Proposed design changes following consultation:

Proposed design changes following consultation:

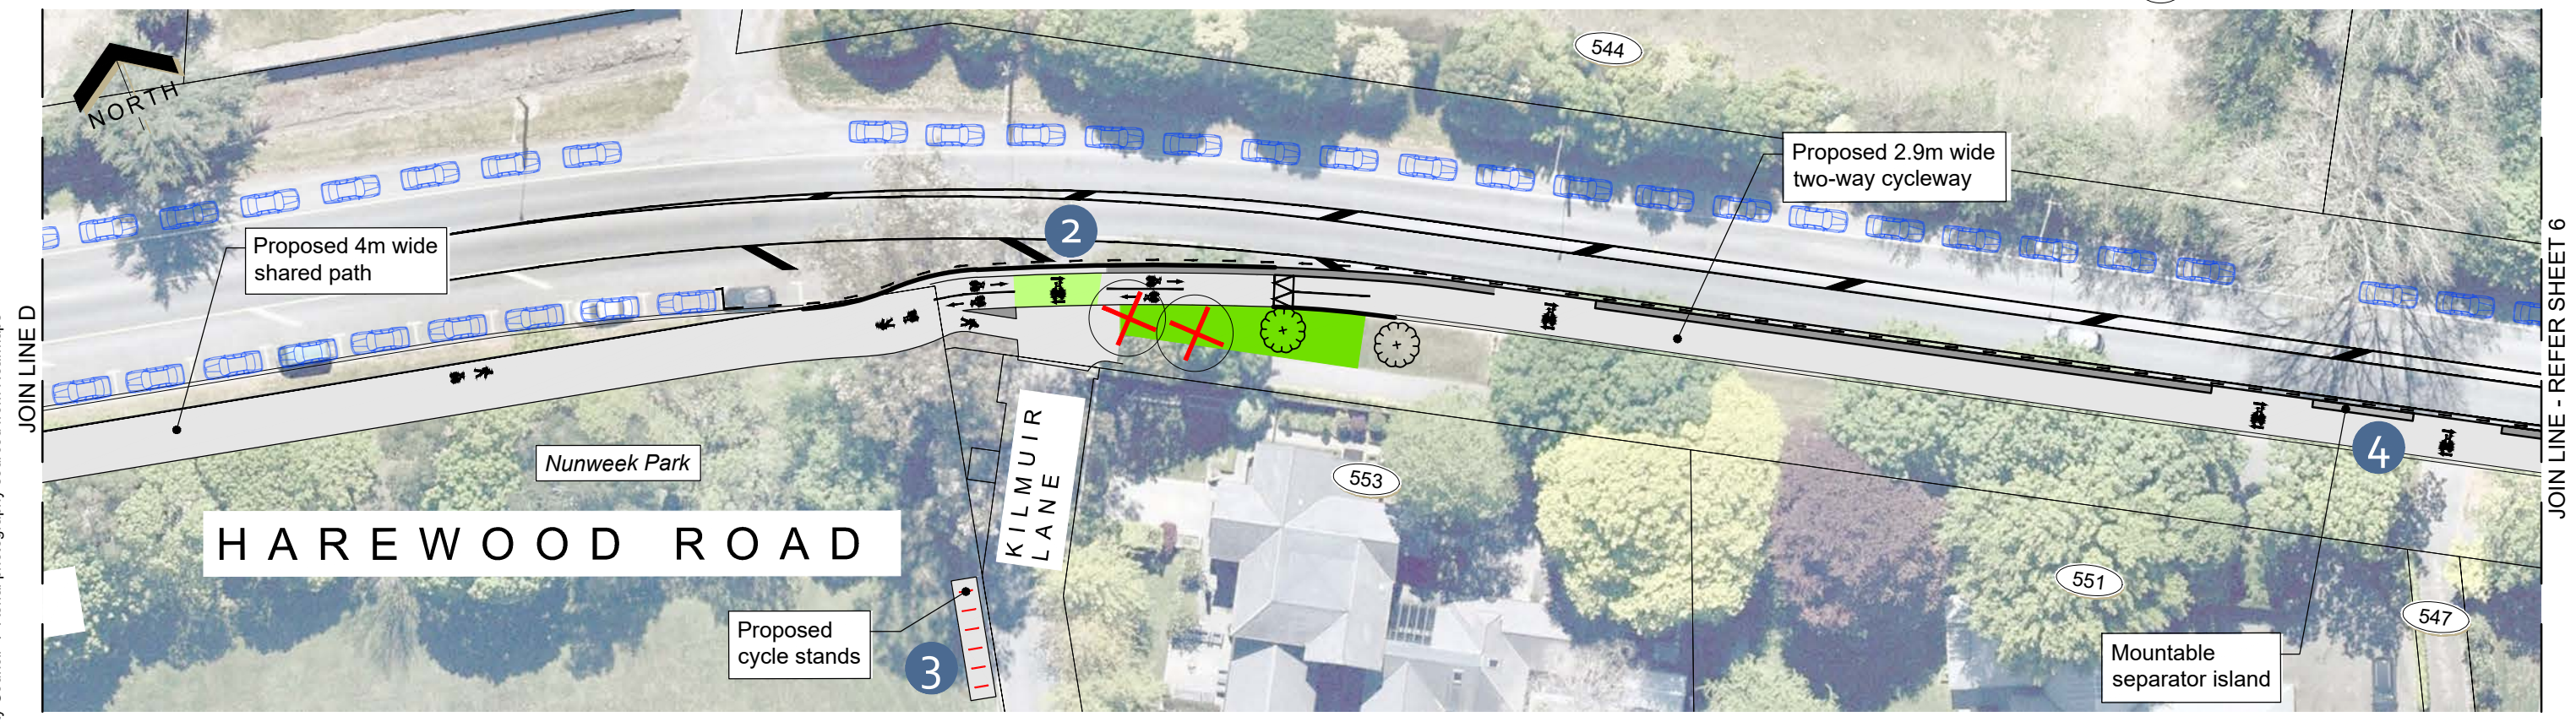
- Proposed design changes following consultation:**
- 1 Cycle stands are added outside Nunweek Park.
 - 2 The cycleway alignment is moved closer to the property boundaries to give drivers turning into Kilmuir Lane more space to wait clear of following traffic.
 - 3 Cycle stands are added near the playground.
 - 4 The section of cycleway separator between the driveways of No. 547 and No. 551 Harewood Road is made mountable.

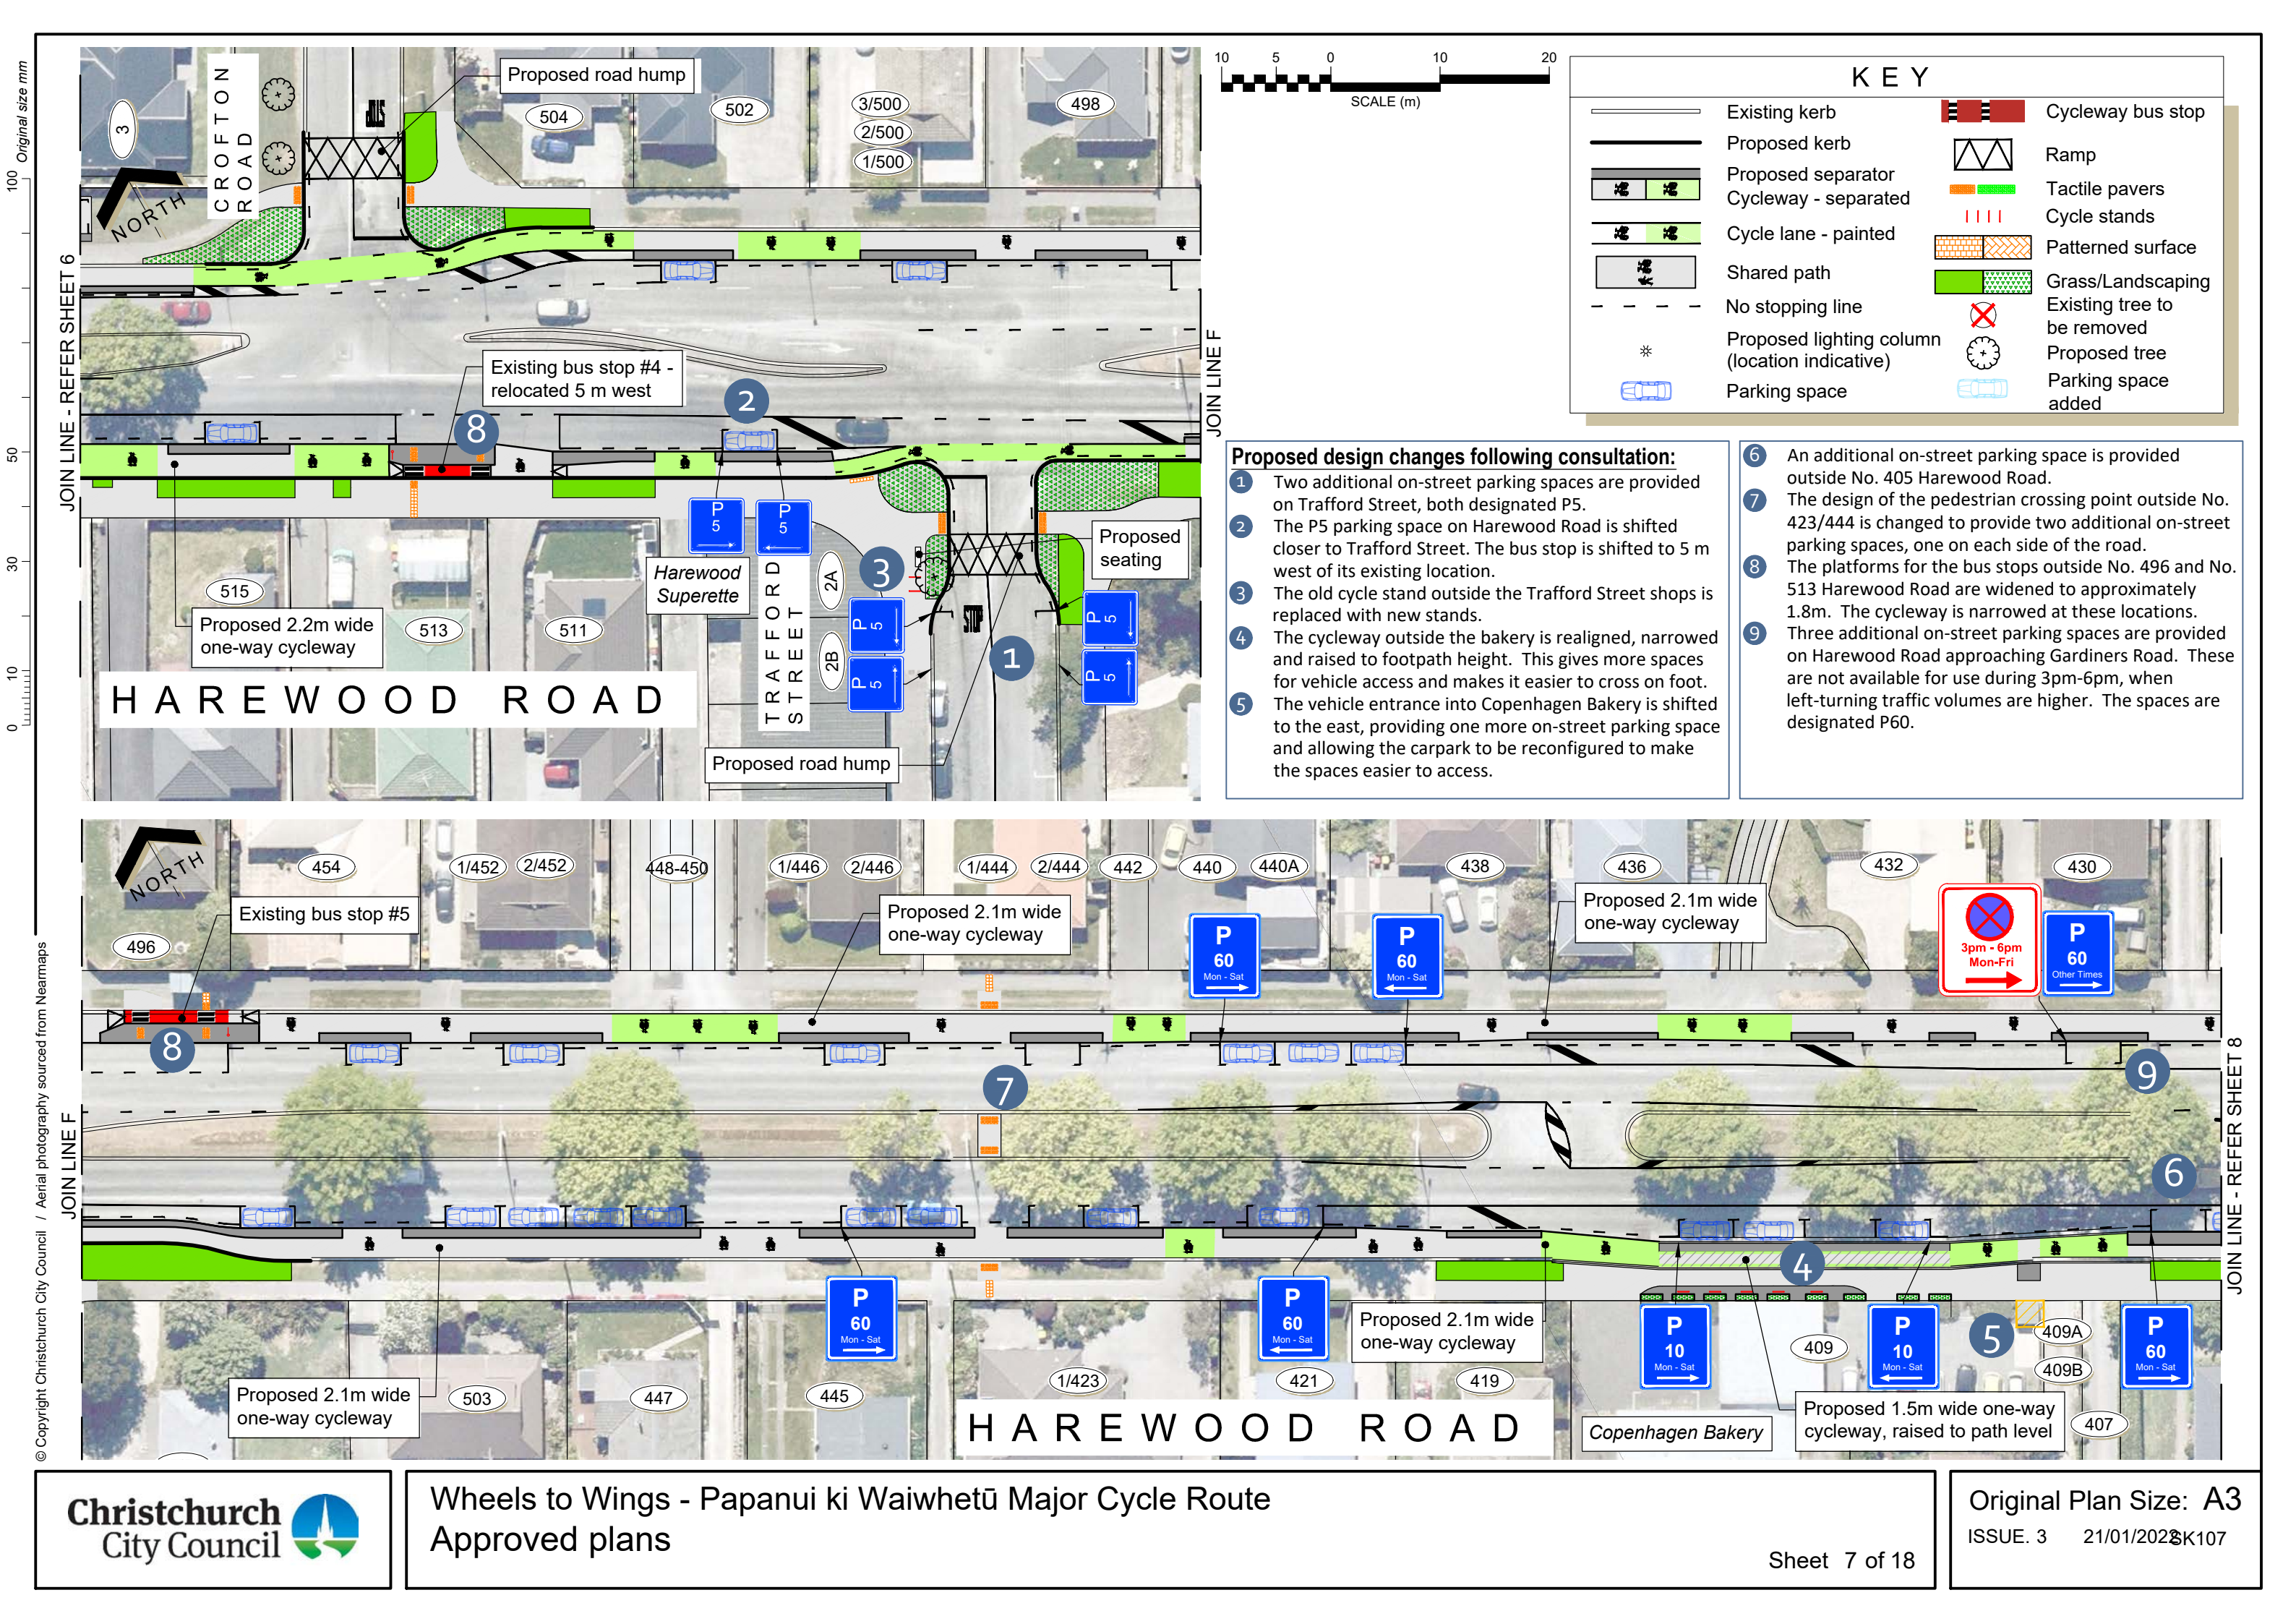
- Proposed design changes following consultation:**
- 1 The cycleway separator is realigned and three on-street parking spaces are added.
 - 2 The cycleway separator outside No. 506 is made mountable so that residents can drive over it when performing a U-turn to enter their driveway.
 - 3 A turning area is added for residents of No. 506 who have less manoeuvre space due to the location of the central median island.
 - 4 The crossing through the central median is widened to make it easier to use.
 - 5 The openings in the cycleway separator at driveways between Nunweek Boulevard and the roundabout are increased to a minimum 5.5 m long.

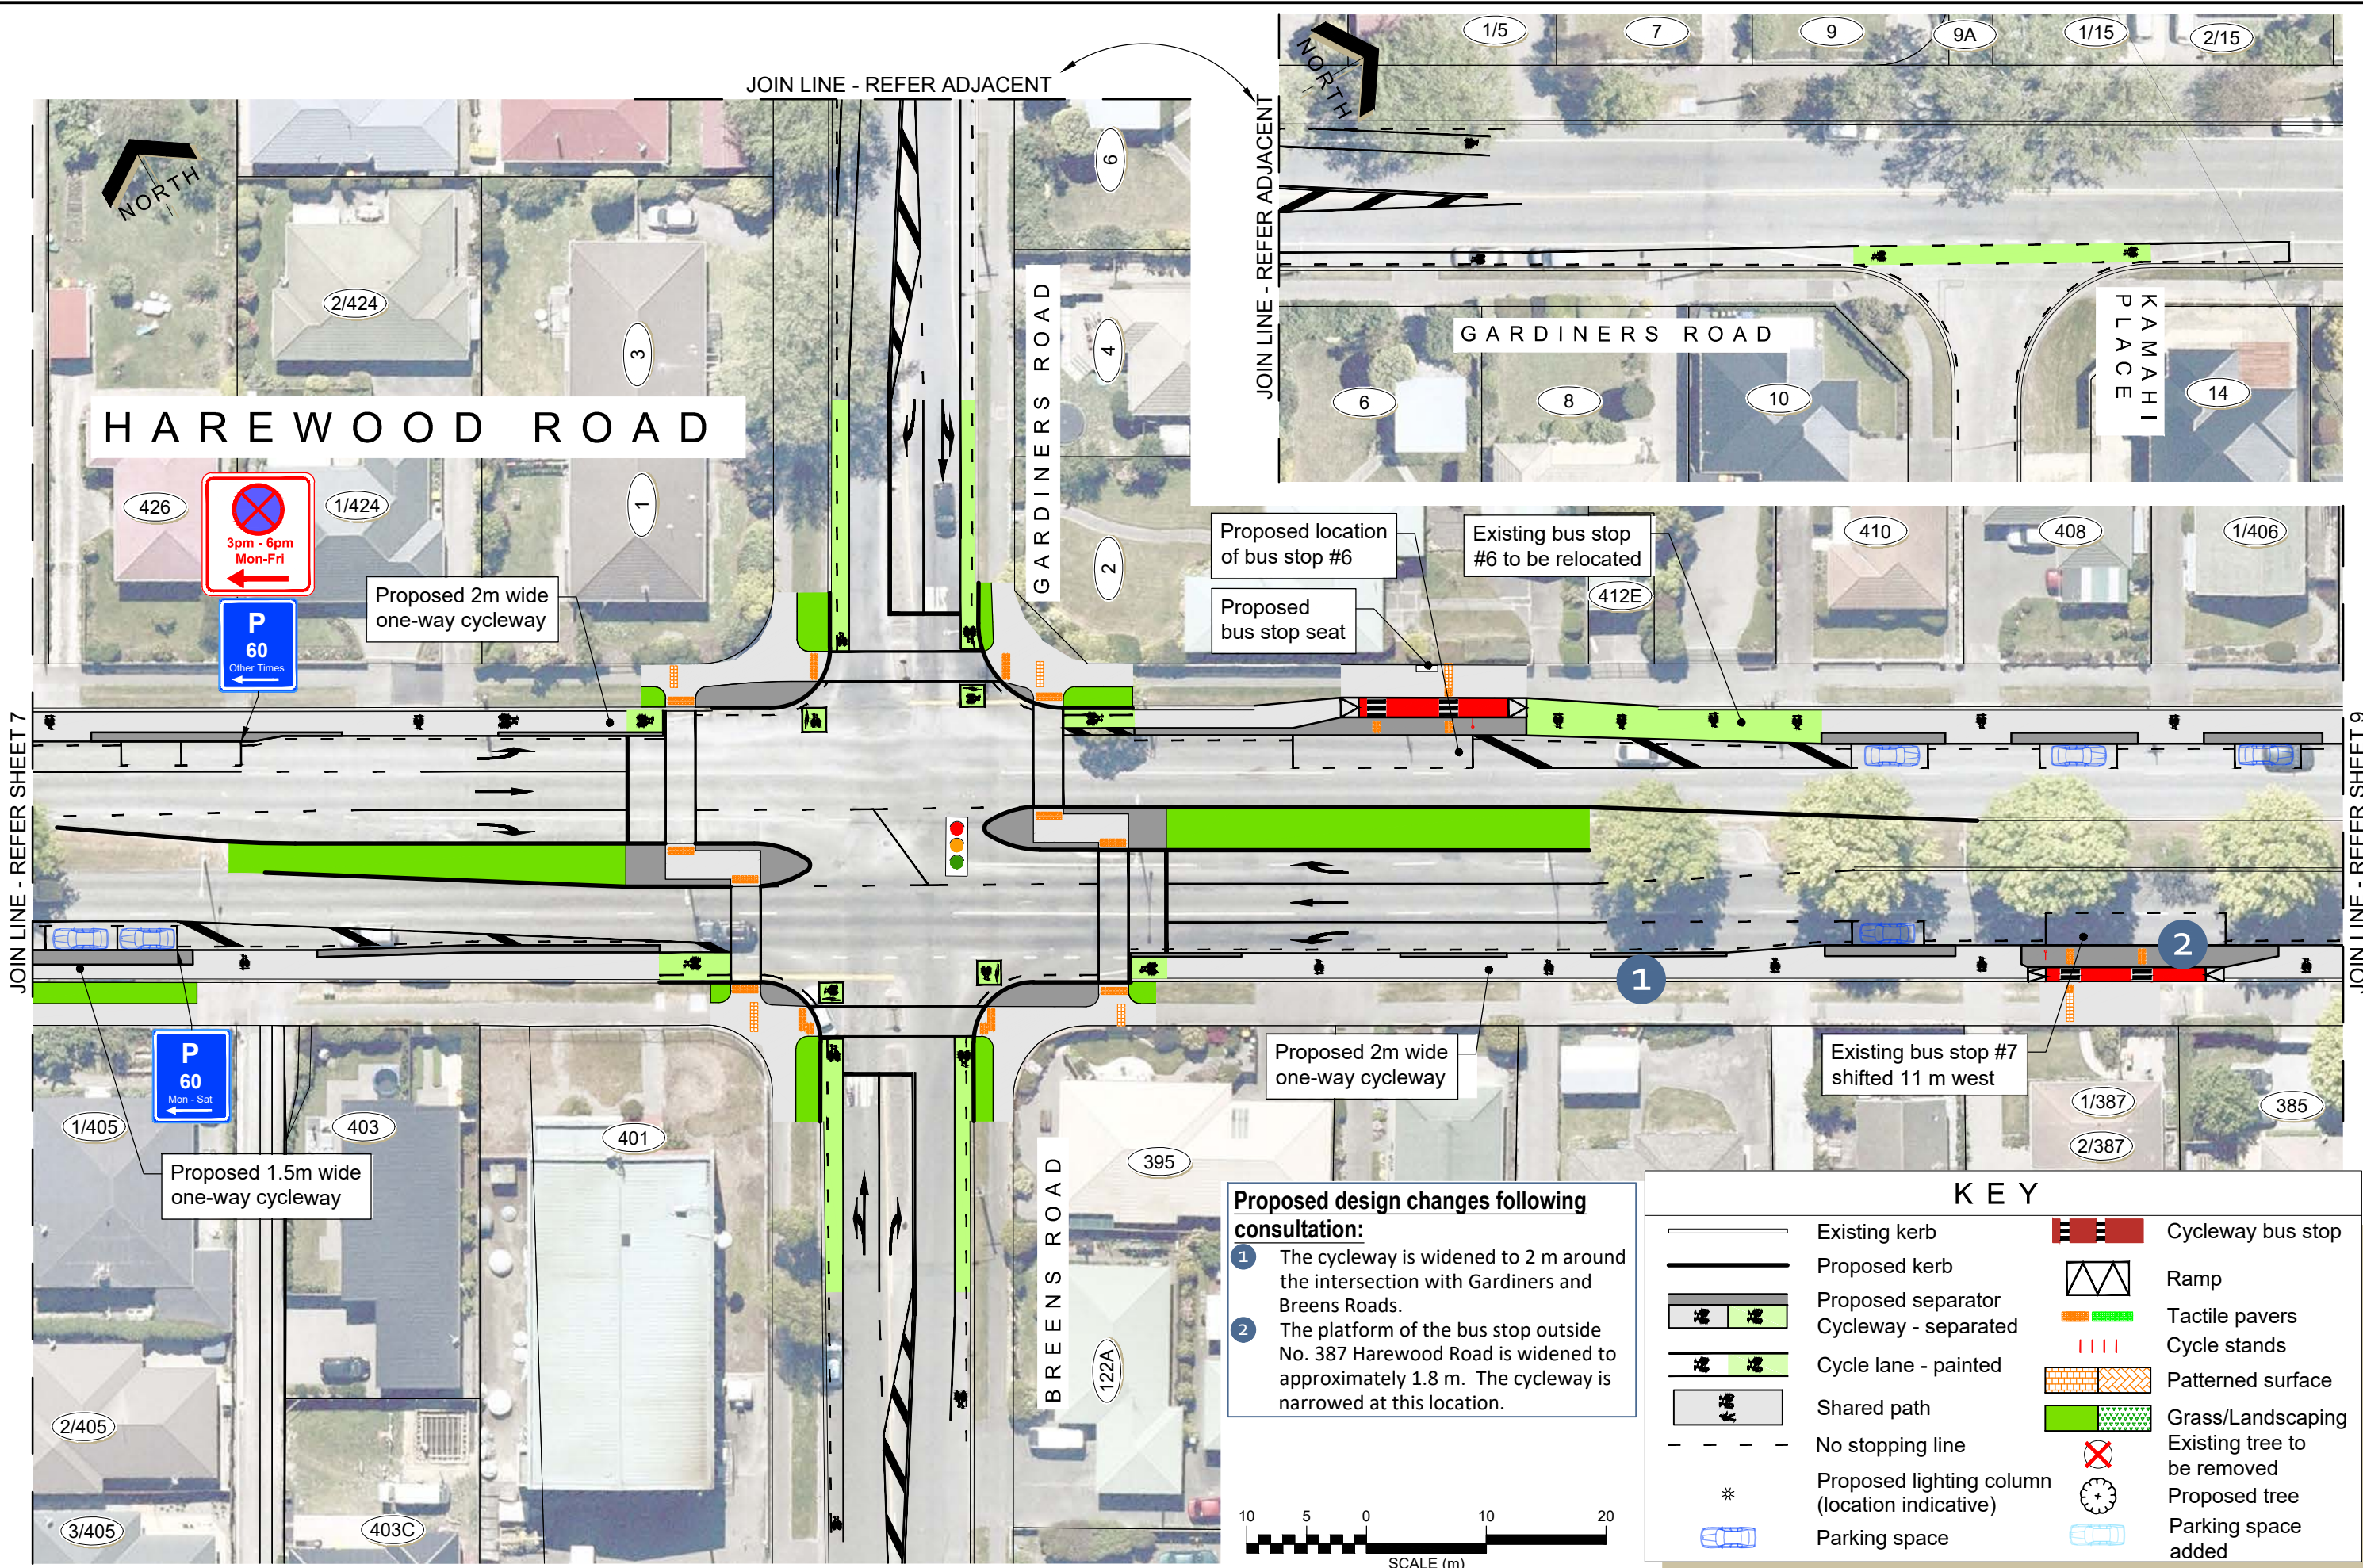
- Two additional on-street parking spaces are provided on Trafford Street, both designated P5.
- The P5 parking space on Harewood Road is shifted closer to Trafford Street. The bus stop is shifted to 5 m west of its existing location.
- The old cycle stand outside the Trafford Street shops is replaced with new stands.
- The cycleway outside the bakery is realigned, narrowed and raised to footpath height. This gives more spaces for vehicle access and makes it easier to cross on foot.
- The vehicle entrance into Copenhagen Bakery is shifted to the east, providing one more on-street parking space and allowing the carpark to be reconfigured to make the spaces easier to access.

- An additional on-street parking space is provided outside No. 405 Harewood Road.
- The design of the pedestrian crossing point outside No. 423/444 is changed to provide two additional on-street parking spaces, one on each side of the road.
- The platforms for the bus stops outside No. 496 and No. 513 Harewood Road are widened to approximately 1.8m. The cycleway is narrowed at these locations.
- Three additional on-street parking spaces are provided on Harewood Road approaching Gardiners Road. These are not available for use during 3pm-6pm, when left-turning traffic volumes are higher. The spaces are designated P60.
